### APR1400 Design Certification

Docket No. 52-046

**RAI No.:** 355-8438

**SRP Section:** 09.05.04 – Emergency Diesel Engine Fuel Oil Storage and Transfer System

Schematic Diagram of Diesel Fuel Oil Storage Tank HVAC System

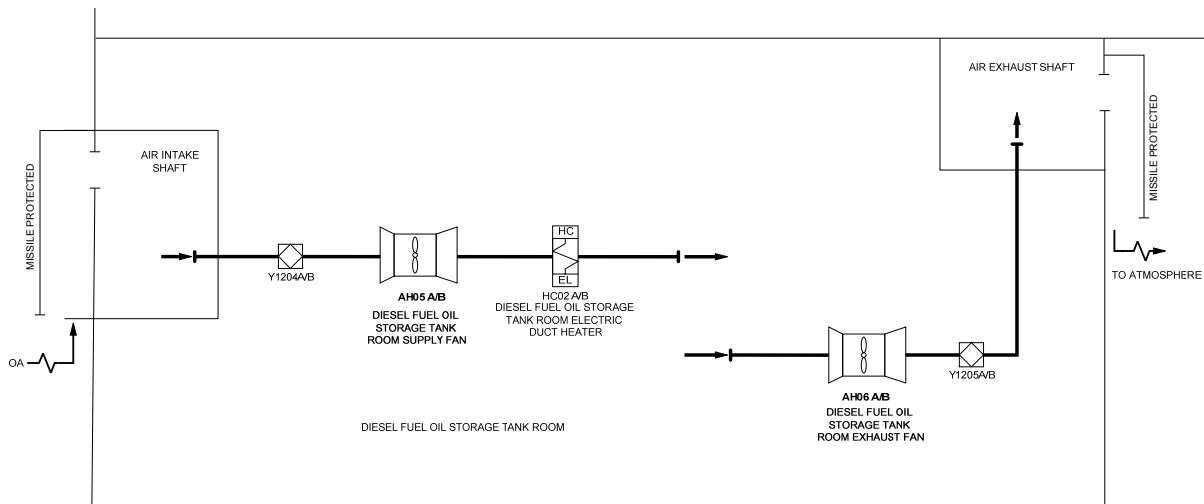
Please describe the codes and standards that will be applied to the coatings on the underground tanks, piping, and other components. In addition, describe your plans to add this information to the FSAR. This information is needed for conformance with position C.9 of Regulatory Guide 1.137, Rev. 2, which states that external corrosion should be addressed by following NACE International standard practice SP0169-2007, "Control of External Corrosion on Underground or Submerged Metallic Piping Systems." If SP0169-2007 is not being used, provide a justification for the proposed alternative. For additional background, the staff notes that License Renewal Interim Staff Guidance, LR-ISG-2015-01, "Changes to Buried and Underground Piping and Tank Recommendations," identifies loss of material on steel and copper components in underground vaults due to moisture in the air.

In the APR1400 design, the diesel fuel oil storage tanks and associated piping are located in vaults, which have dedicated HVAC systems as described in DCD Tier 2, Subsection 9.4.5.2.1.3. Supply and exhaust fans for the diesel fuel oil storage tank rooms operate continuously to prevent possible accumulation of oil fumes and to provide ventilation during all modes of plant operation. The electric duct heater operates to maintain the minimum required room temperature in the diesel fuel oil storage tank room. A sketch of the dedicated HVAC system is shown below (DCD Tier 2, Figure 9.4.5-1 provides a more detailed drawing of the system).

Therefore, the air condition in the vault does not have higher moisture content than uncontrolled indoor air conditions in plant spaces within buildings.
